Memorandum Date: July 27, 2009
Meeting Date: August 5, 2009

AGENDA ITEM TITLE: PUBLIC HEARING AND ORDER/IN THE MATTER OF APPROVING A PROJECT DESIGN CONCEPT FOR PEARL STREET AND COBURG INDUSTRIAL WAY AS PART OF AN OREGON DEPARTMENT OF TRANSPORTATION PLANNED COBURG INTERSTATE-5 INTERCHANGE AREA IMPROVEMENT PROJECT

Coburg / Interstate-5 interchange Area Management Plan
Pearl Street / Coburg Industrial Way Improvement Project

Pearl Street with Swale and Sidewalk
Sta. 24+50 to Sta. Sta30+00

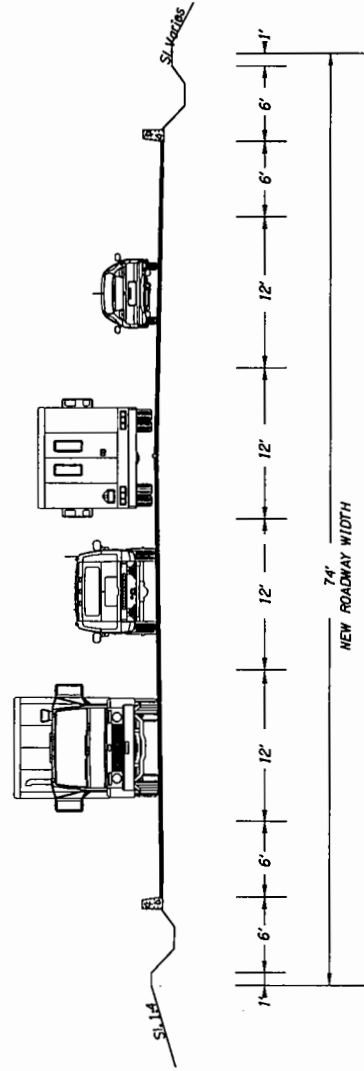
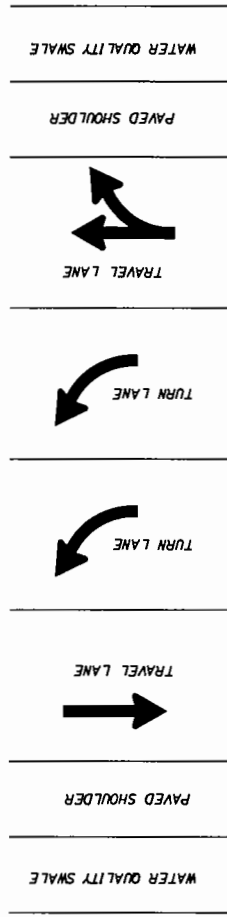
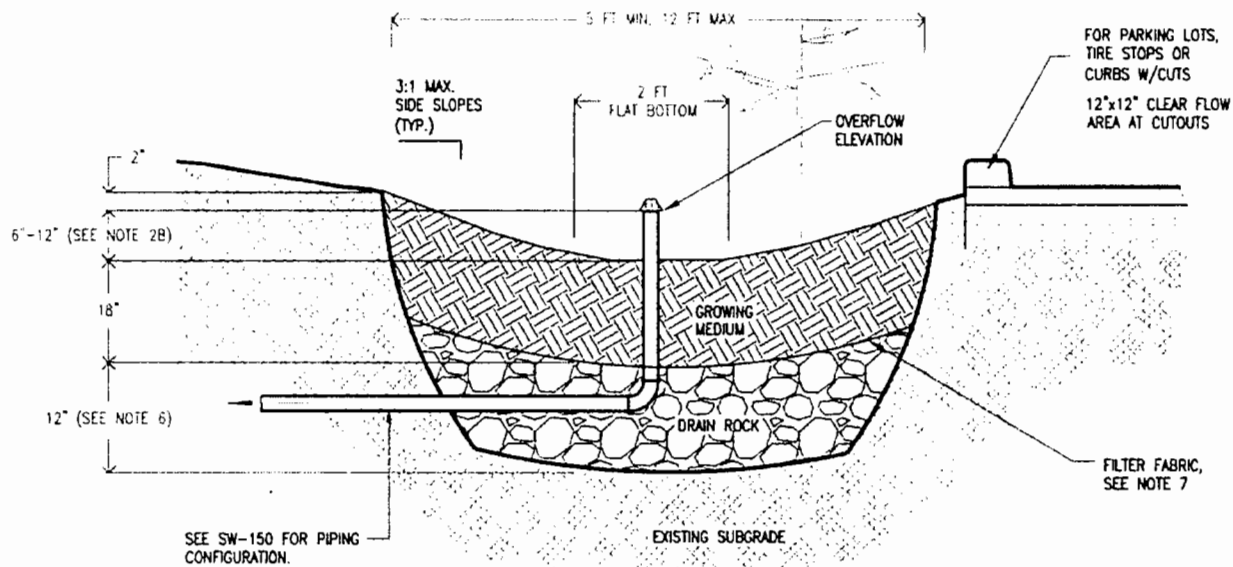
The 6-foot wide setback space between the curb and sidewalk is proposed for a bio-swale. Lane Code does not have standards for bio-swailes. County design standards require a minimum 6-foot wide planting area for a setback sidewalk design. The proposed bio-swale is a continuous shallow depressions lined with various types of plants. Bio-swale design detail is shown in attachment 2-c. Overflow water will drain into two nearby detention ponds shown on attachment 2-d. It is County's expectation that the City or ODOT will maintain these swales.

(b) Swale vs. Planter Strip

The proposal replaces planter strips with Water Quality Swales. The Department of Environmental Quality required swales for treatment of stormwater runoff on Pearl Street and Coburg Industrial Way. Documentation of environmental issues is provided in the ODOT briefing.

The objectives of a planter strip is to provide more physical separation for pedestrians from vehicles and space for street trees, landscaping, ground cover, or turf and provide aesthetic benefits to the streetscape. The bio-swales perform as an effective traffic separator, as planter strips do. However, they do not provide the aesthetic benefits that planter strips do.

- (2) Construct bio-swales in place of planter strips that would typically be required by Lane County design standards.
- (3) Provide paved shoulders both sides for use as multi-use shoulders at this phase.
- (4) Provide 6-foot wide sidewalks on both sides.

PROJECT BACKGROUND

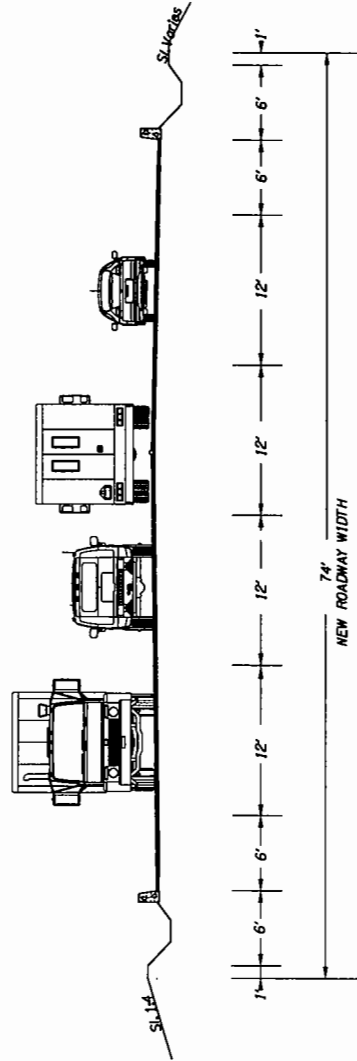
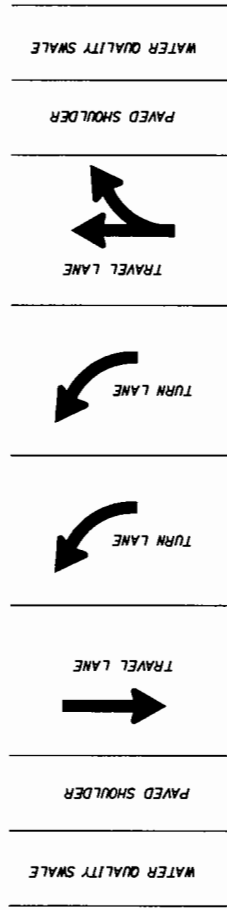
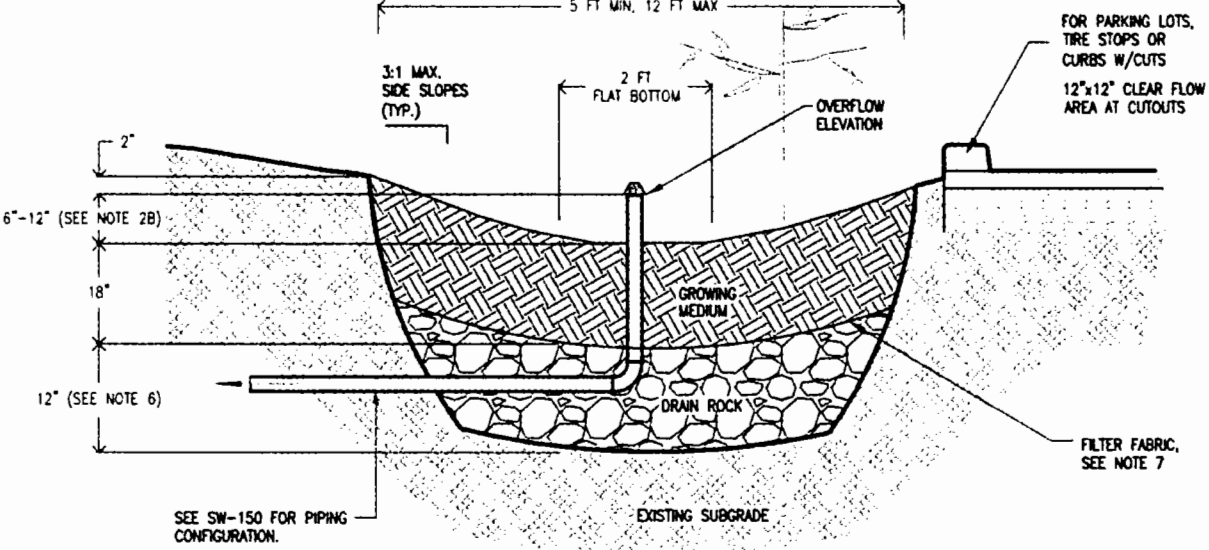
Coburg Industrial Way is not provided with sidewalks as required by Lane County design standards found in LC 15.702. Staff and ODOT met several times to decide whether sidewalks are required on Industrial Coburg Way. Staff finds that a sidewalk on the east side of the road (only in the area of the intersection) is not warranted at this time due to lack of sidewalk facilities further north and beyond the scope of the proposed intersection improvement. Moreover, a sidewalk on the west side is not required at this time, as a multi-use path is planned for construction by the City of Coburg and is included in the City Parks adopted Plan. Land use conditions of approval for a private development proposal on the

There is no sidewalk or bike lane proposed on Coburg Industrial Way. A future sidewalk is proposed as part of the future private development. Staff recommended not requiring sidewalks on Coburg Industrial Way based on the finding that this project is scoped to improve the intersection only. A sidewalk on the east side is not warranted, as there is no development on this side of the road and there is no connecting sidewalk to the north of the intersection. A sidewalk on the west side will be required for serving proposed private development. The developer is required to provide a sidewalk or contribute to the planned city multi-use path that is in the City's adopted Parks Plan.

- (1) Construct two, 12-foot wide through lane and two 12-foot wide dual turn lanes for the first 275 feet of approach as shown in attachment 2-b. Tie back to the existing two lanes with required taper length.
- (2) Construct bio-swales in lieu of planter strips on both sides of the road, provided the City or ODOT will maintain them.
- (3) Deviate from the requirement of sidewalks in LC 15.702.
- (4) Provide for a future bike lane for the impacted 700 feet of Coburg Industrial Way.
